RotorSport UK Ltd Service Bulletin (Permit)

Title: Cavalon mast-cowl infill		
SB-108 Iss1	Related documents Modification: None- rationalisation only CCAR No.: None	Compliance Category: OPTIONAL or RECOMMENDED or MANDATORY
Applicability		
Aircraft type & model: Cavalon	Aircraft serial Nos. affected: RSUK/any	
The maintenance manual to be referenced is this stated or subsequent issue.		RSUK0288 Iss: 4
<p>This form is the response from RotorSport UK Ltd either against a problem found in the product in service requiring a containment or rectification action, or as service information for aircraft modification incorporation. For help, contact RotorSport on 44(0)1588 505060, or email compliance@rotorsport.org.</p> <p>The technical content of this document is approved under the authority of the UK CAA Design Organisation Approval Ref: DAI/9917/06</p>

Single piece mast-cowling with split at rear

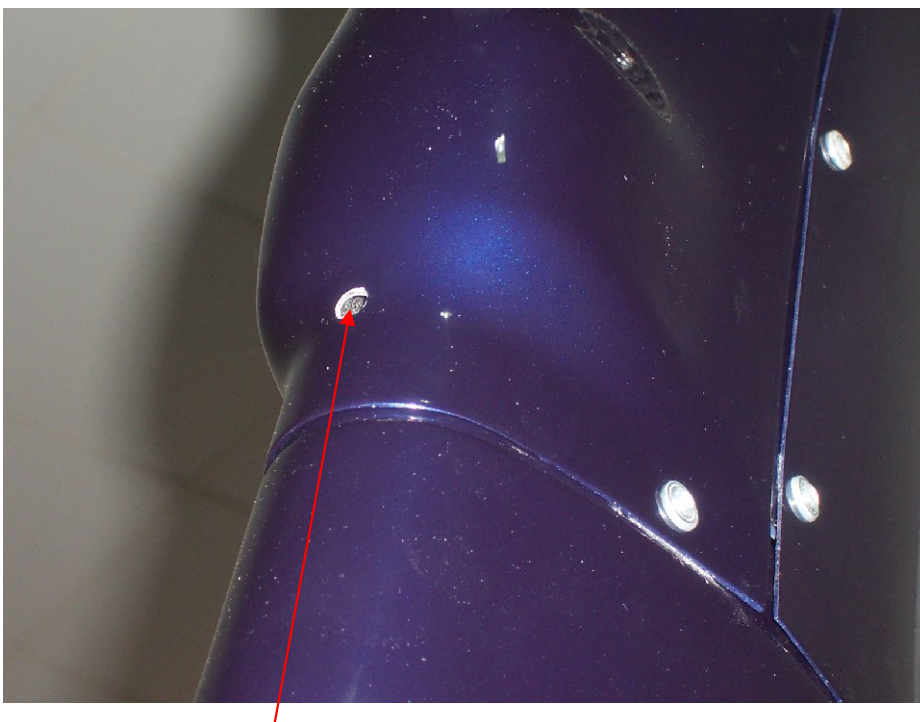
1. Remove the mast cowlings – early aircraft have a single moulding split at the rear, later aircraft (RSUK/CVLN/009 onwards) have a two-piece assembly.

- Using the photograph below for reference, re-arrange, or if necessary fit new Kompriband foam into the lower mast, filling the apertures through which the push-pull cable and air cylinder pass. Ensure that the foam does not make contact with the pre-rotator shaft.

- Before re-fitting the mast cowl(s) drill a drain-hole 6.0-6.5mm diameter through the rear face of the cowling, just above the level of the Kompriband top surface. With the two-piece cowling the hole may be on centre-line, with the one piece cowling position the hole slightly to the right of centre to avoid disturbing the split junction. Touch-up the paint edge if required.
